RS-00-101

September 29, 2000

Quad Cities Nuclear Power Station, Units 1 and 2
Facility Operating License Nos. DPR-29 and DPR-30
NRC Docket Nos. 50-254 and 50-265

Subject: Request for Technical Specifications Change, Transition to General Electric Fuel

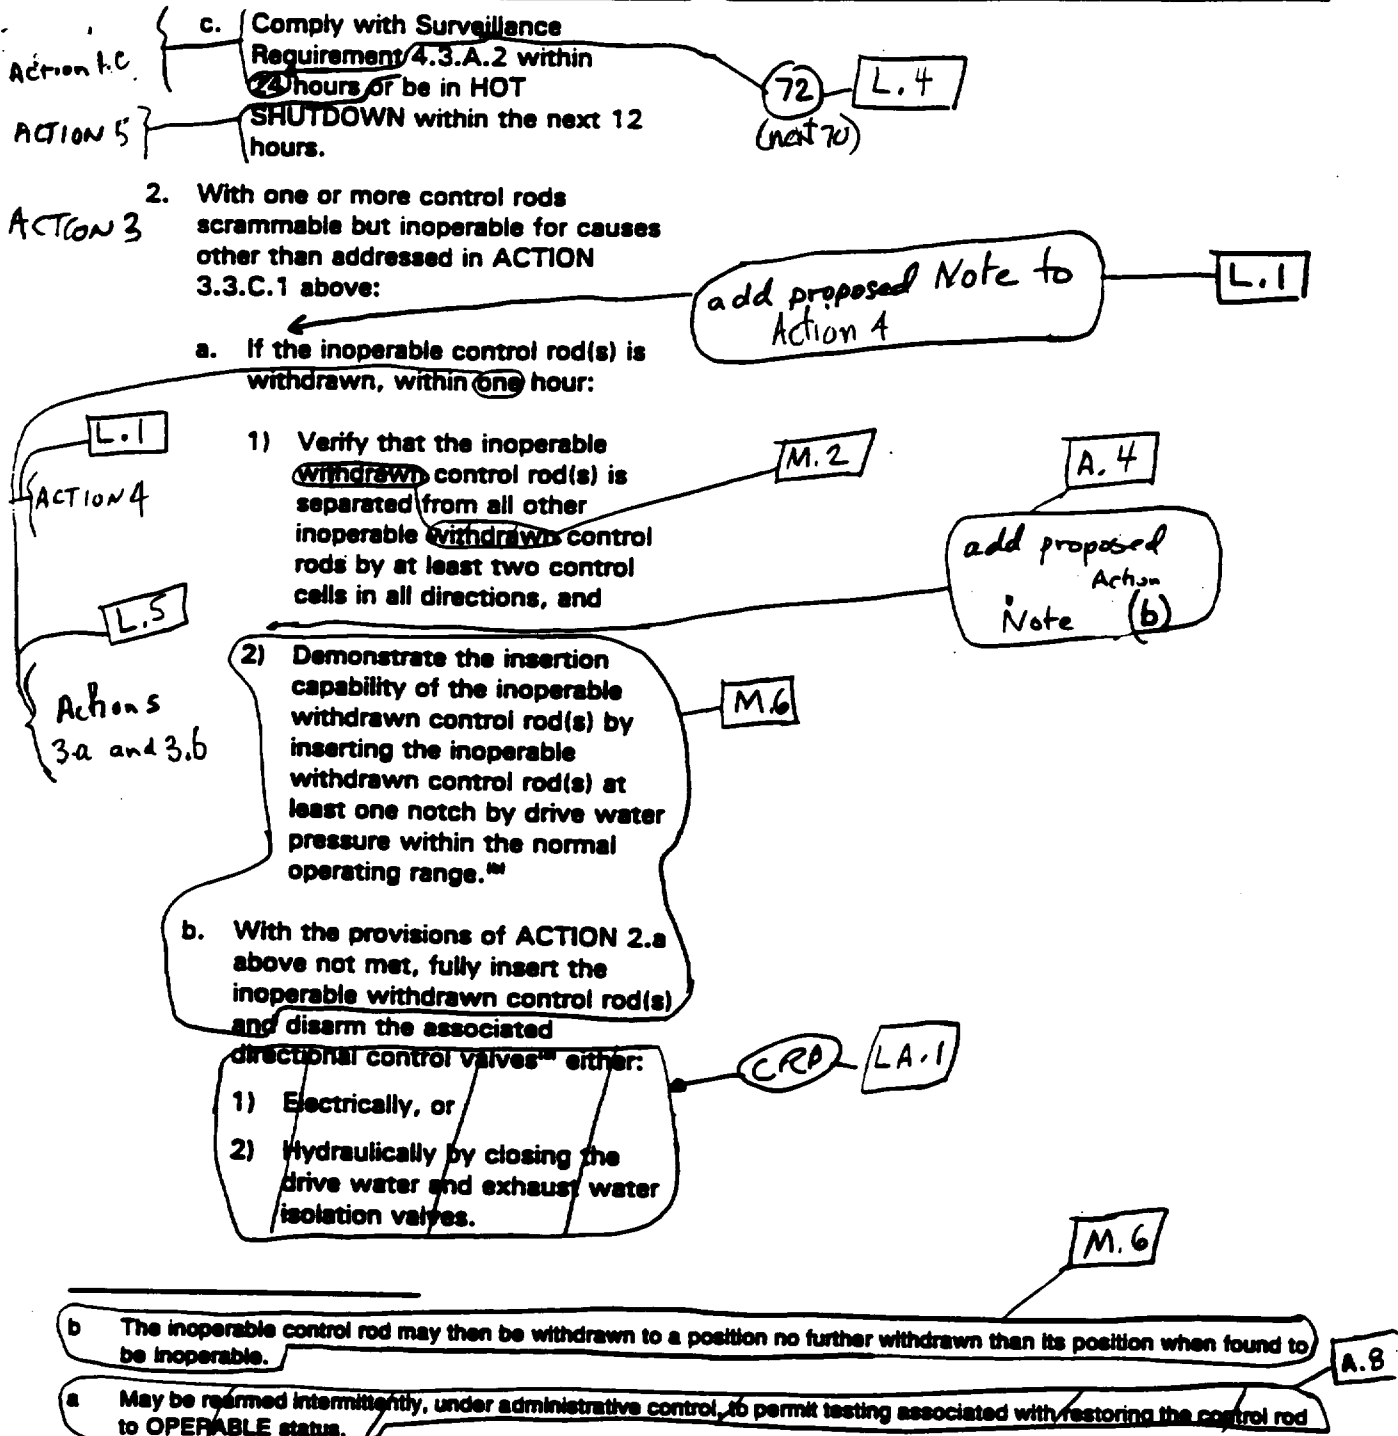
a May be required intermittently, under administrative control, to permit testing associated with restoring the control rod to OPERABLE status.

A.8

REVISED LCO 3.3.C
CR OPERABILITY 3/4.3.C

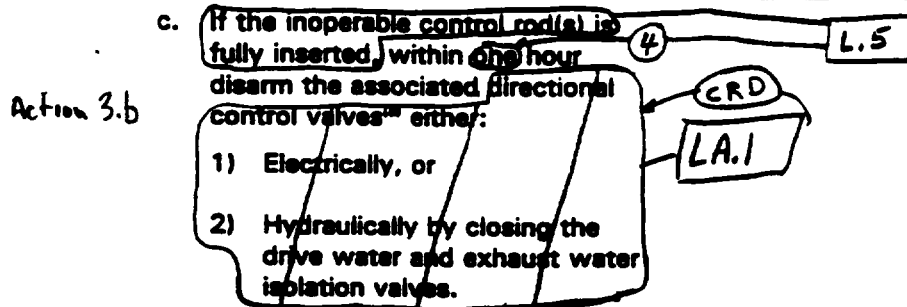
ACTION 5 3. With the provisions of ACTION 2 above not met, be in at least HOT SHUTDOWN within the next 12 hours.

3/4.3-9

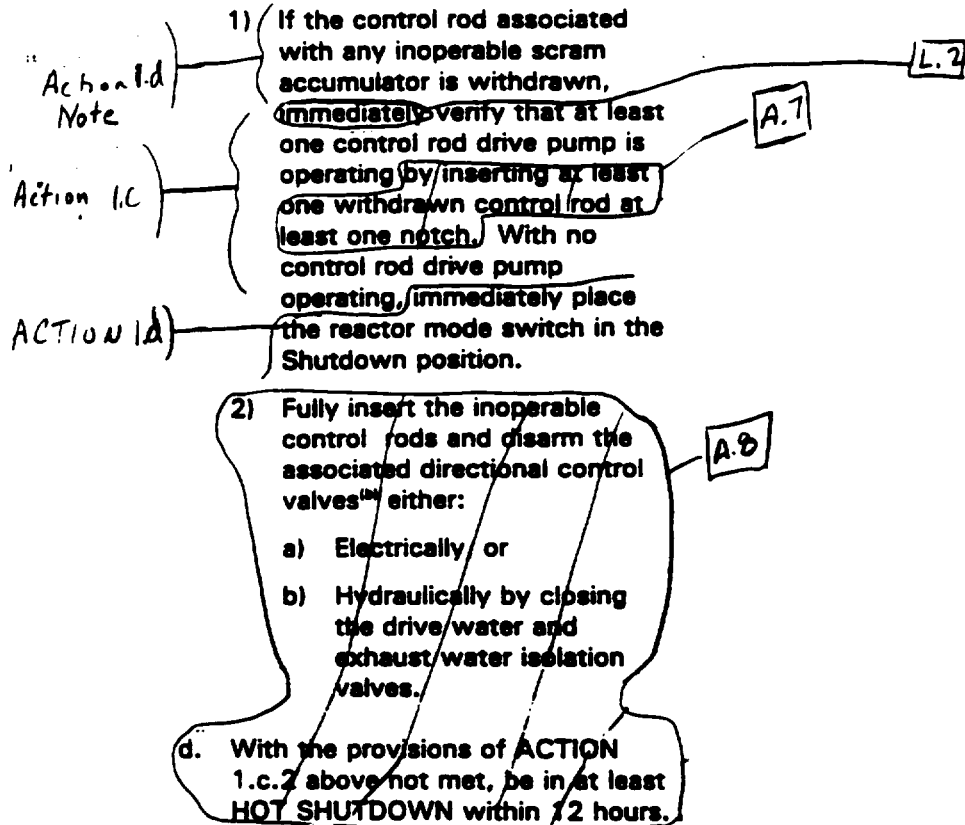
add proposed
Action 1.b.i

CONTROL ROD OPERABILITY

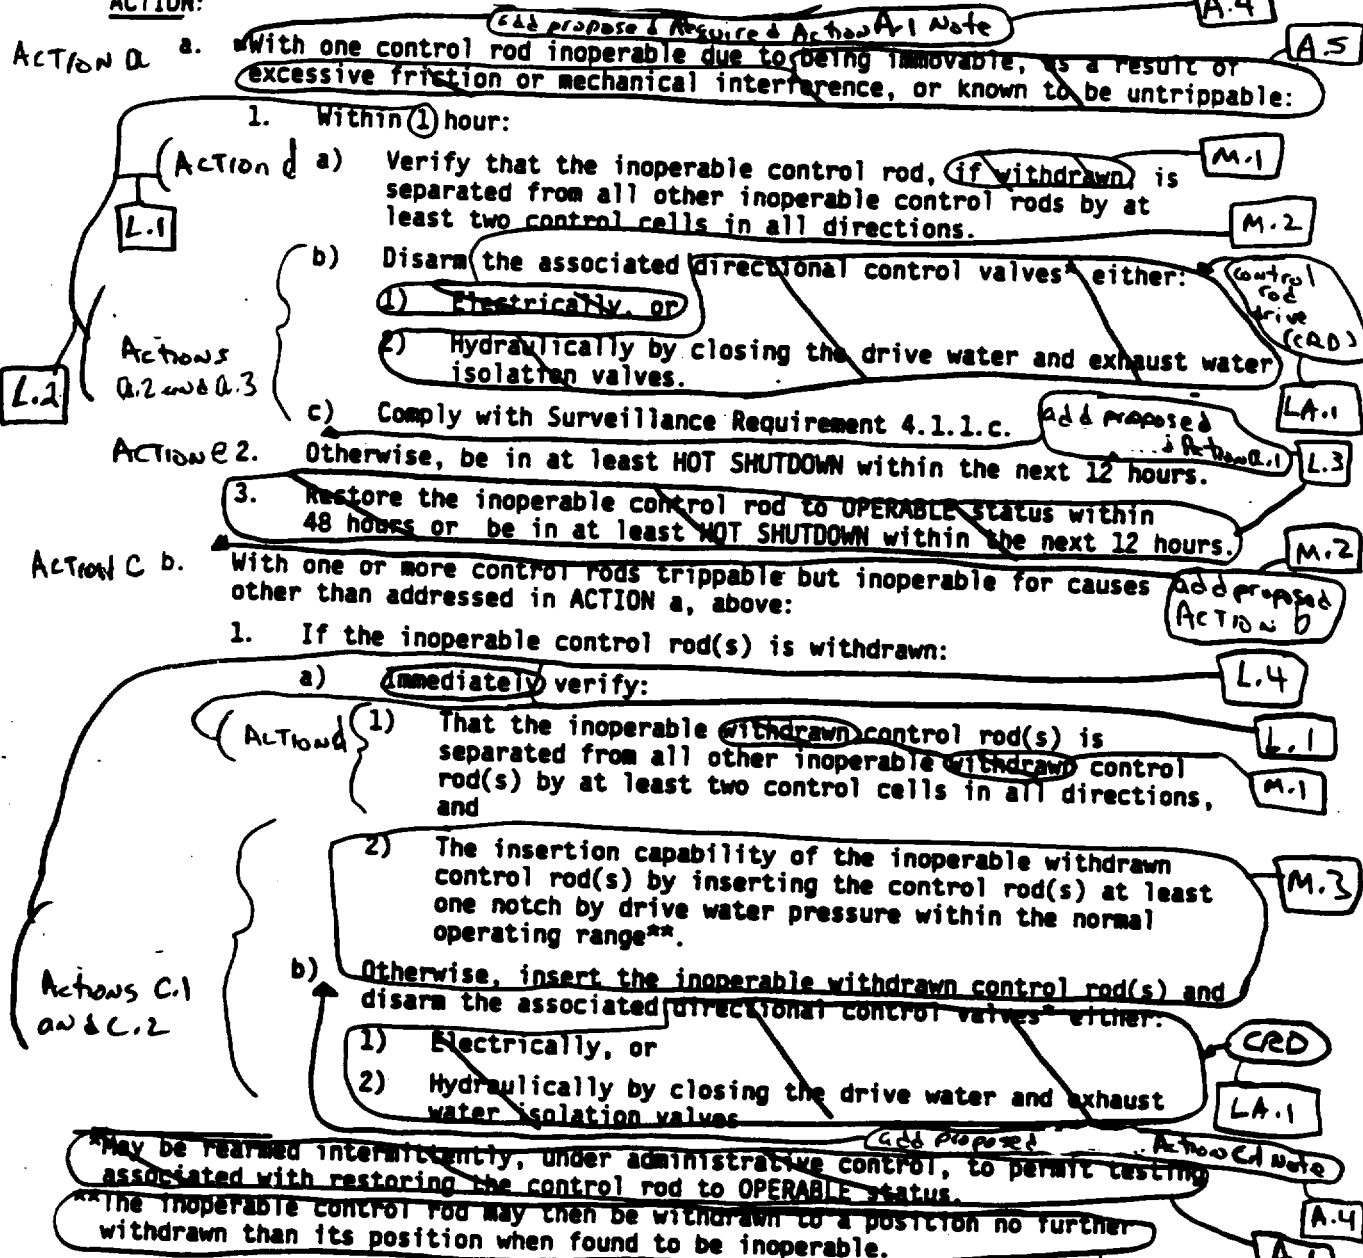
<general reorganization>

A.2
